TECHNICAL SERVICE BULLETIN

10045

MODEL(S): 150GTL, 200GTL

DESCRIPTION: "Speed-up" the echo effect (add reverb).

150 GTL

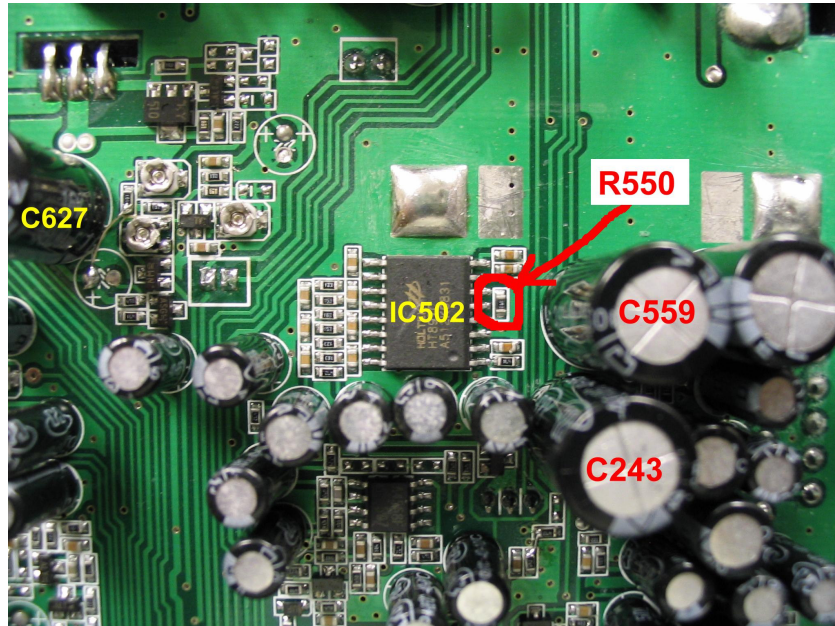
ACTION: Reduce R550. Recommended value to try: 22K Ω .

See page 2 for the location of R550.
